REVISION TRANSMITTAL

This sheet transmits Revision 1 to MTL-32-03 which:

MANDATORY**MTL-32-03****TITLE**

LANDING GEAR - LANDING GEAR CONTROL SWITCH INSPECTION

Figure 1. Landing Gear Control Switch Inspection (Sheet 1)

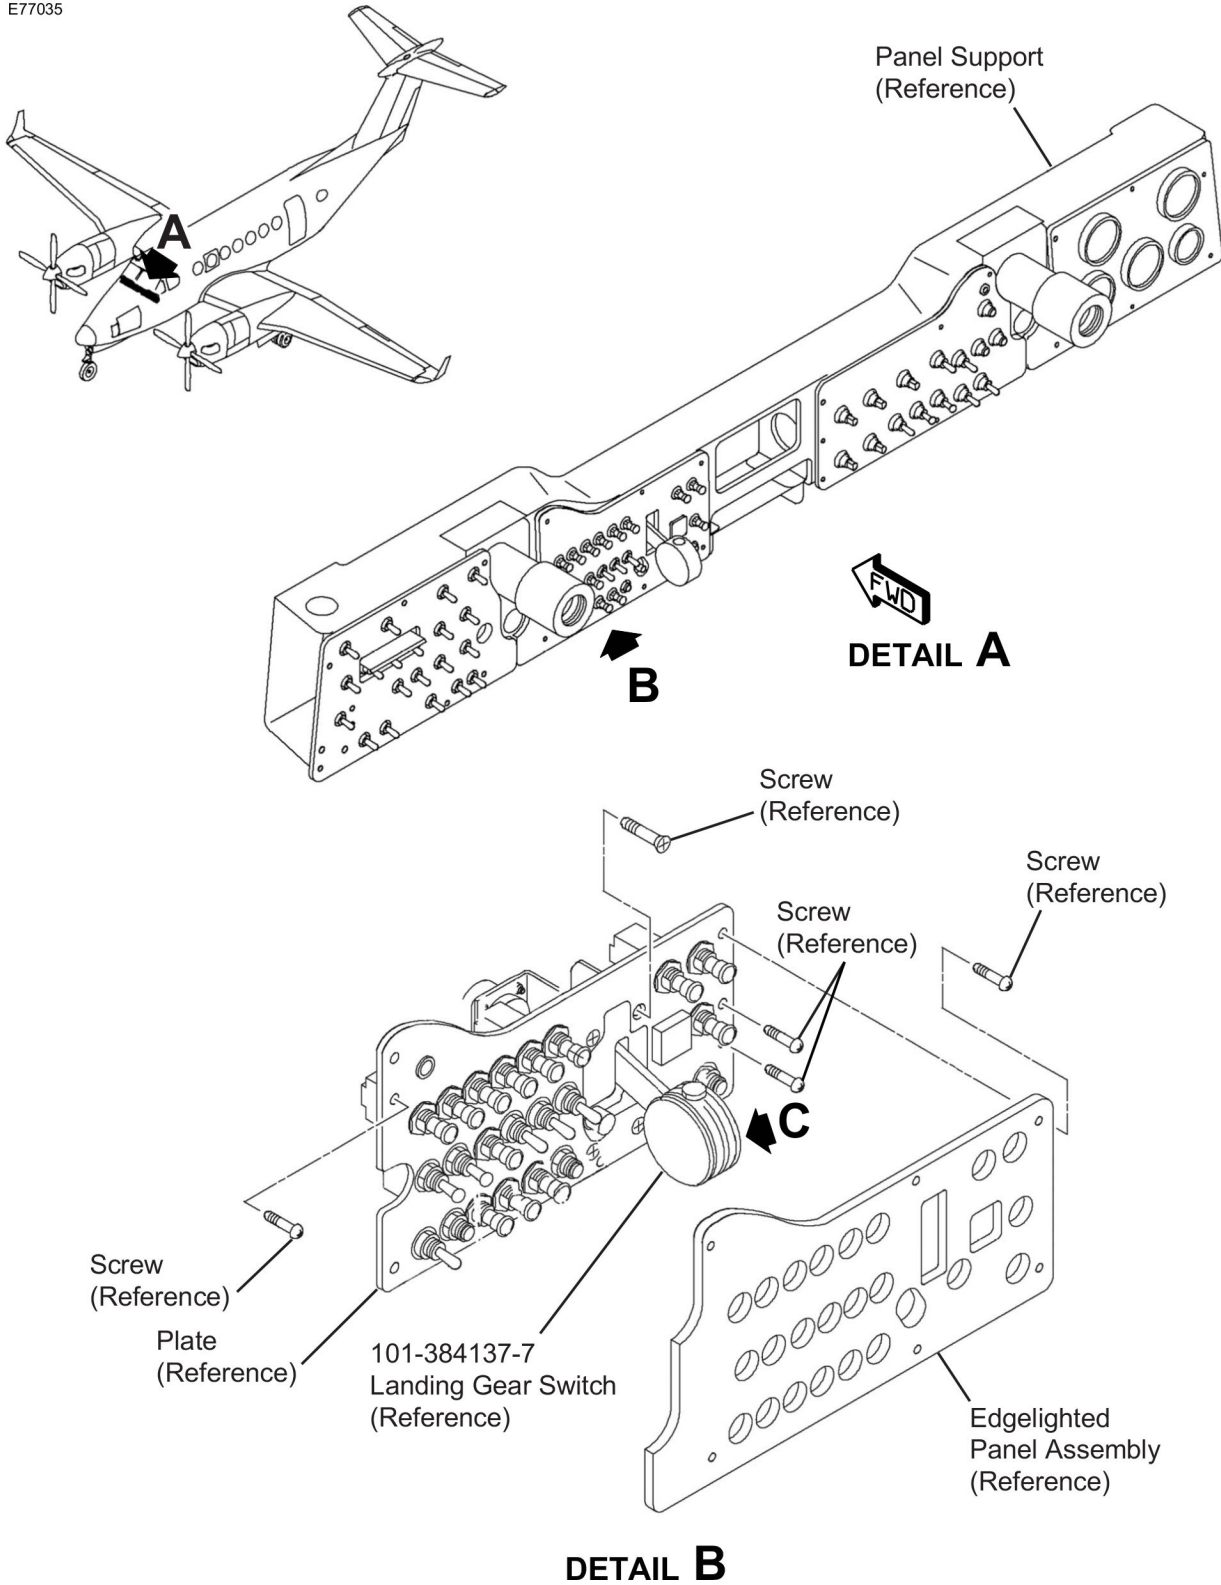
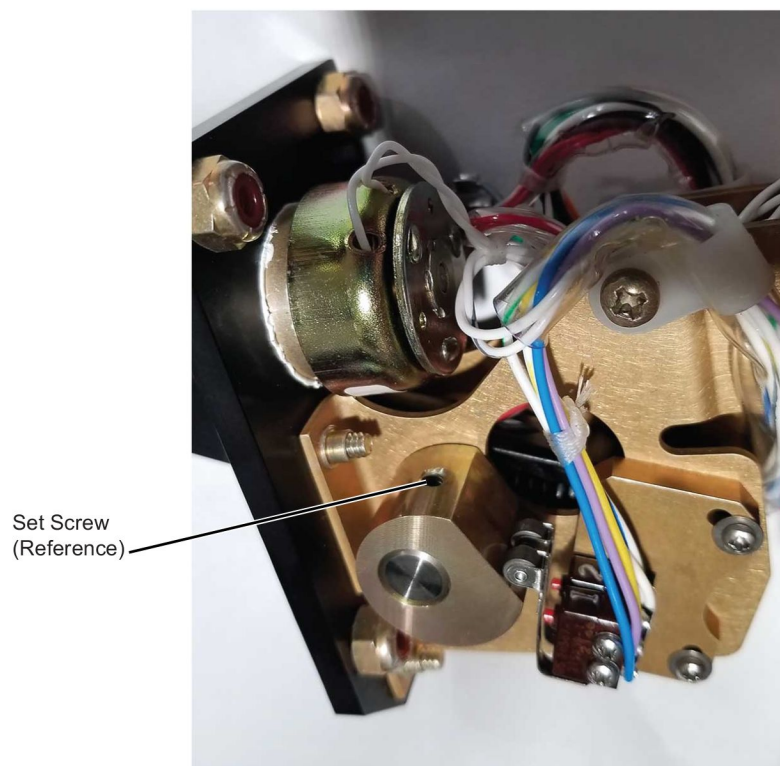
2. (Refer to Figure 1, Sheet 1.) Remove and retain the screws that attach the electroluminescent panel and plate to the panel support.
 - A. Retain the electroluminescent panel and plate.

4. (Refer to Figure 1, Sheet 1.) Remove and retain the screws that attach the 101-384137-7 Landing Gear Control Switch to the plate.
5. Pull the 101-384137-7 Landing Gear Control Switch from the instrument panel and disconnect the electrical connector.

Figure 1. Landing Gear Control Switch Inspection (Sheet 2)

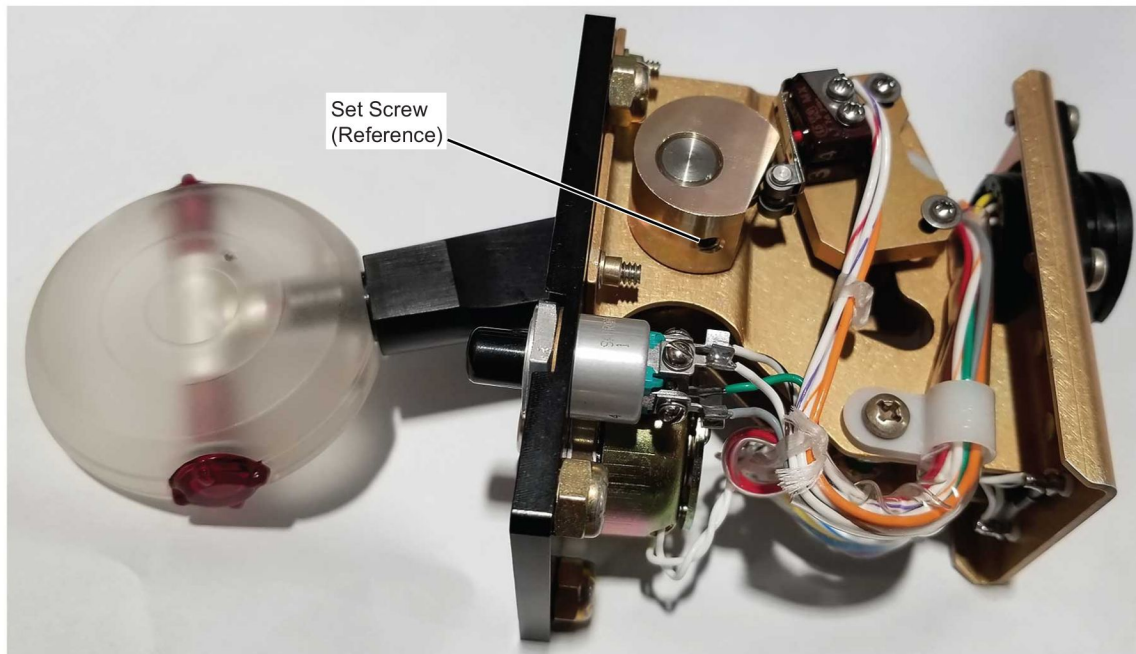
6. (Refer to Figure 1, Sheet 2.) Do a visual inspection of the set screw in the 101-384137-7 Landing Gear Control Switch cam.
 - A. If evidence of adhesive, (such as Loctite 242 thread locker) is visible in the set screw, go to Step 6.

- B. If no evidence of adhesive, (such as Loctite 242 thread locker) is visible, do as follows:
 - (1) Hold or lock the cam in place prior to set screw removal.

- (2) Remove the set screw from the cam.
 - (3) Apply a drop of U074062 (Loctite 242, thread locker) Adhesive to the threads of the set screw.
 - (4) Install the set screw in the cam.
